Service Bulletin

Bulletin No.: PI0093A

Subject: Intermittent Click/Clunk Type Noise from Steering Column Area During Turns

Models: 2009-2012 Chevrolet Colorado
2009-2012 GMC Canyon

2443279

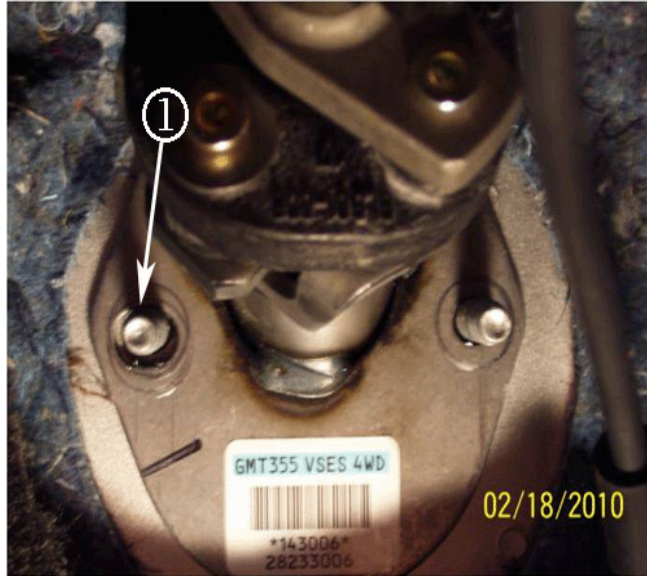
Some customers may comment on a click or clunk type noise from the steering column only when turning the steering wheel. They also may feel a slight pop from steering wheel or steering column housing.

The cause of this condition may be due to the toe plate stud orientation being at the bottom of the slot (1).

Remove the cowl stud fastener nuts located under the driver's dashboard by the pedals. Slightly shift the plate downward on the left side, causing the left stud to be at the top of the enlarged hole (1) as shown above. Reinstall the nuts and tighten to specification.
